Change Request

Description: Police Facility: RFI 126 - Trench Drain Reinforcement

RFI

Subject: Police Facility: Rebar Detail At Trench Drains in Sally Port

6-3/4 [171] WIDE REVEAL TRENCH DRAIN SYSTEM
WITH HEAVY-DUTY FRAME ASSEMBLY

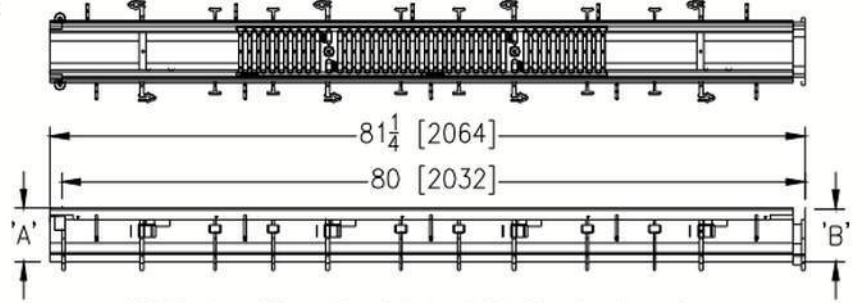
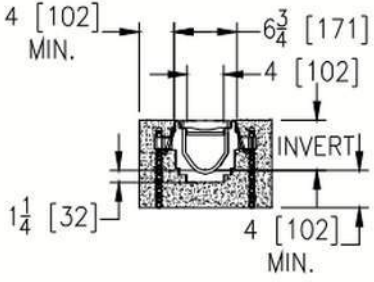
Per submittal 221300-001 Sanitary Drainage, page 50 of 54 states, "Specifying engineer is responsible for concrete encasement and reinforcing based upon application and local codes". Per the plans a detail(s) cannot be found referencing the reinforcement and concrete encasement at the trench drains located in the Sally Port. Please advise.

SPECIFYING ENGINEER IS RESPONSIBLE FOR CONCRETE ENCASEMENT AND REINFORCING BASED UPON APPLICATION AND LOCAL CODES

Please see the sheets provided by the Structural engineer of record for reinforcing.

1 FOUNDATION PLAN - OPERATIONS LEVEL

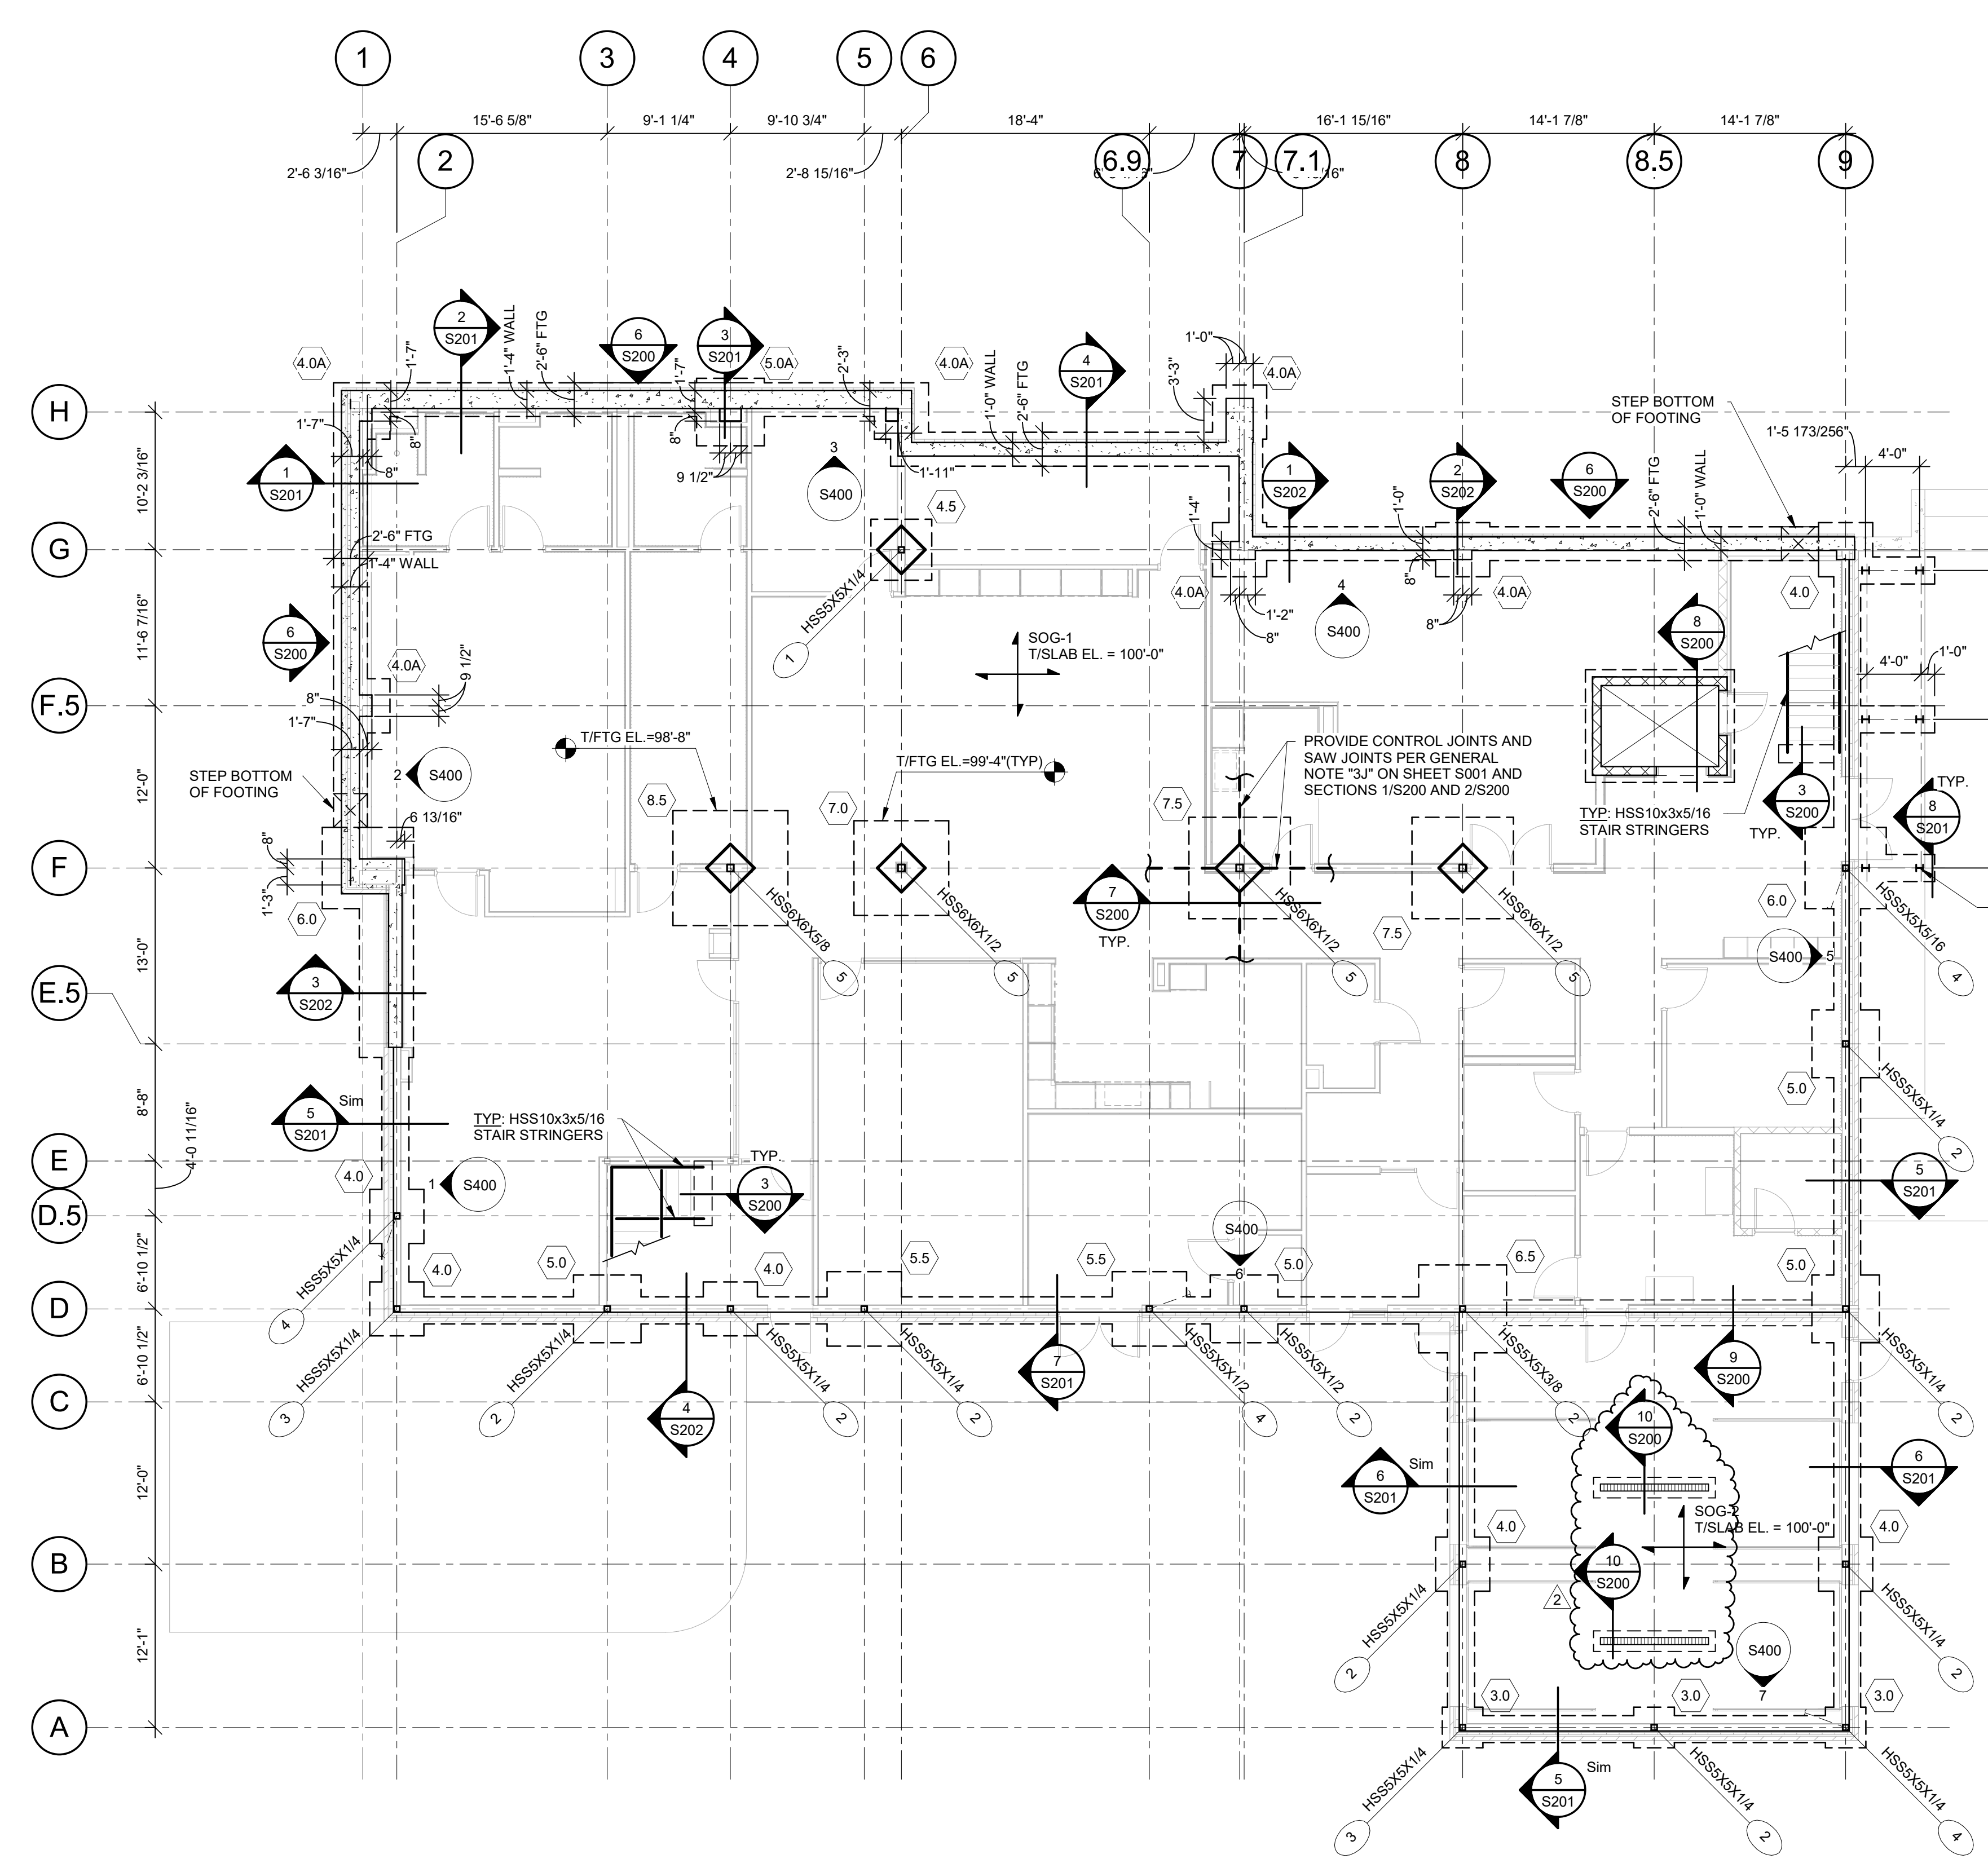
MAR.	DATE	DESCRIPTION
2	12/6/19	RFI-126
